**Commonwealth Edison**

Subject: Byron Station Units 1 and 2  
Braidwood Station Units 1 and 2  
High and Moderate Energy Pipe  
Break Analyses  
NRC Docket Nos. 50-454, 50-455,  
50-456, and 50-457

QUESTION 010.40

FIGURE Q010.40-1: HELB Zones of Influence - El. 346'0"

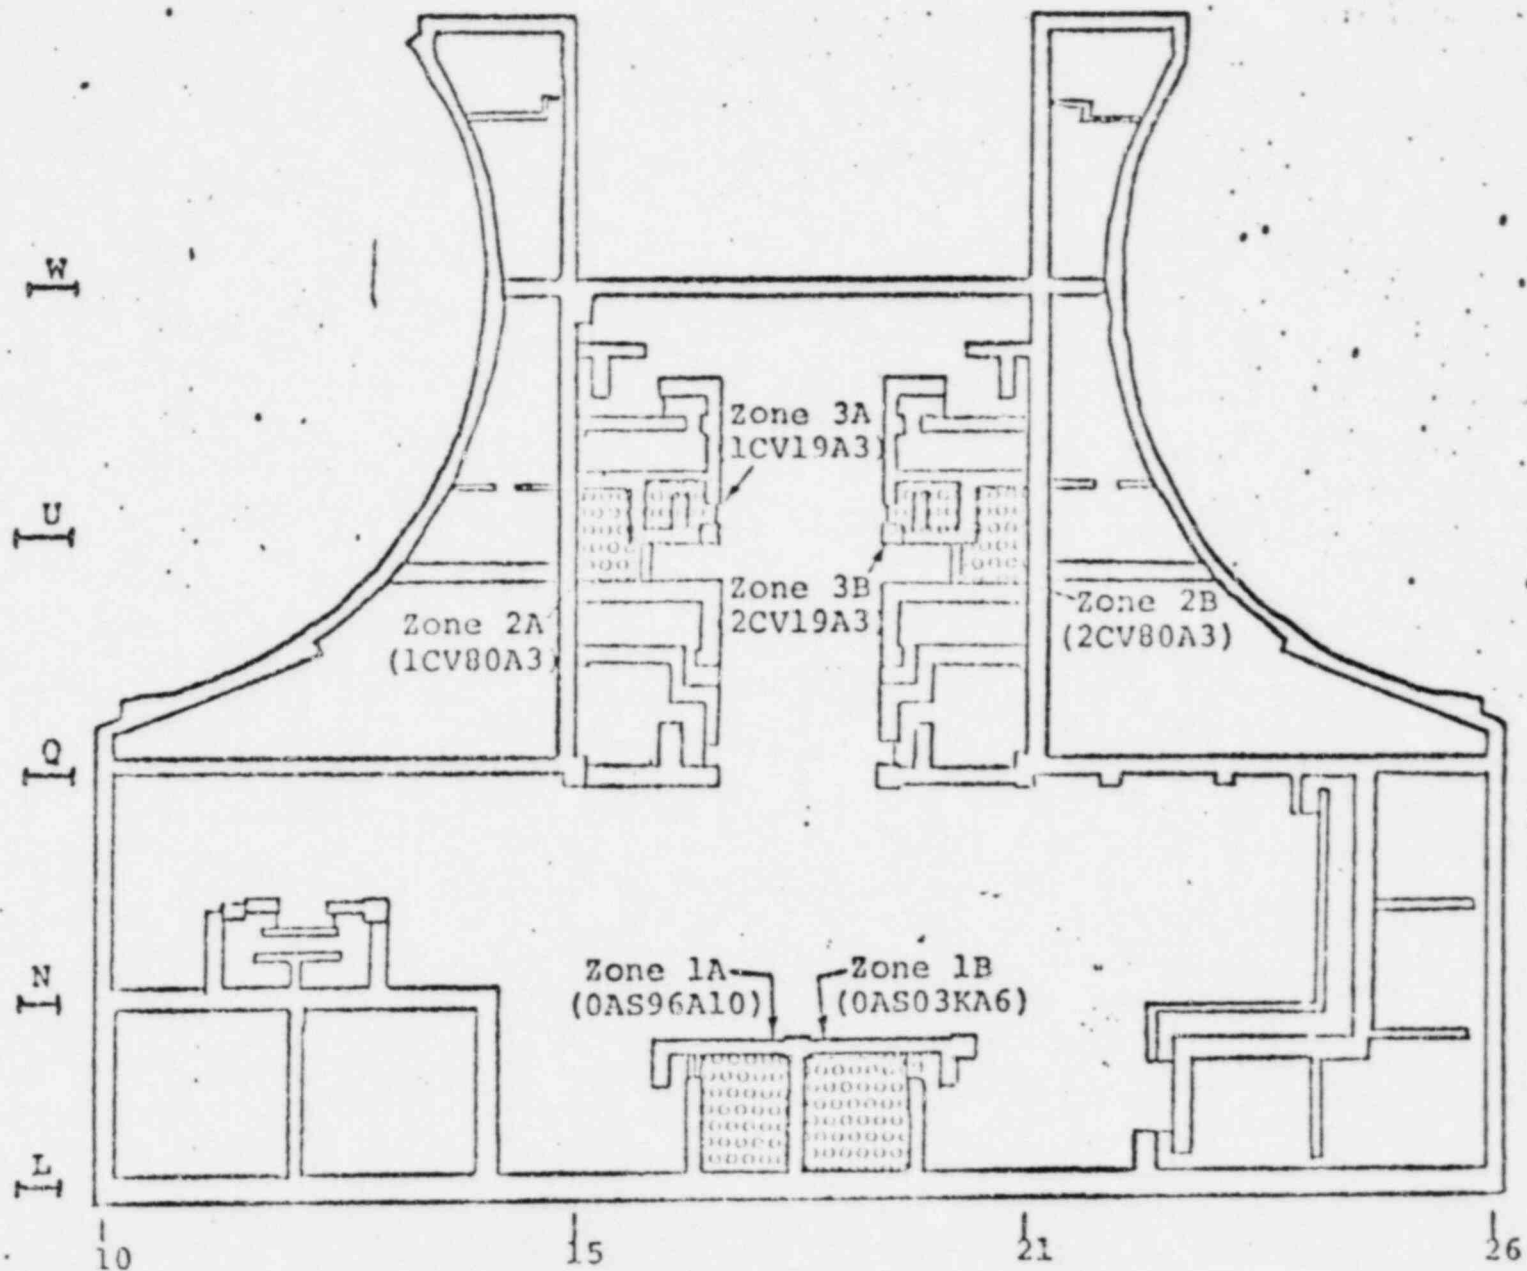
"Provide a response to Question 010.17 and include the following in your response. Provide the results of analyses of the effects on safety-related systems of failures in any high or moderate energy piping system in accordance with the J. F. O'Leary letter of July 12, 1973, as defined in Branch Technical Position ASB 3-1, Appendix C. Provide a table which identifies the method of protection provided all safety-related systems listed in FSAR Table 3.6-1 from failures of any high or moderate energy systems listed in FSAR Table 3.6-2. Include figures depicting the locations of failures relative to the systems of FSAR Table 3.6-1 giving dimensions, locations and protective method for each postulated break or crack in a high or moderate energy system. Include the assumptions used in your analysis such as flowrates through postulated cracks, pump room areas, sump capacities, and floor drainage system capacities."

Figure Q10.40-1 represents elevation 346 feet 0 inch. Zone 1, the recycle waste evaporator room, has been analyzed and the results are reported in Section A3.6 of the FSAR. Zones 2 and 3, letdown reheat heat exchanger rooms and valve areas, have been analyzed and the results are reported in Section A3.6. The assessment in A3.6 addressed Zone 3, the more limiting zone.
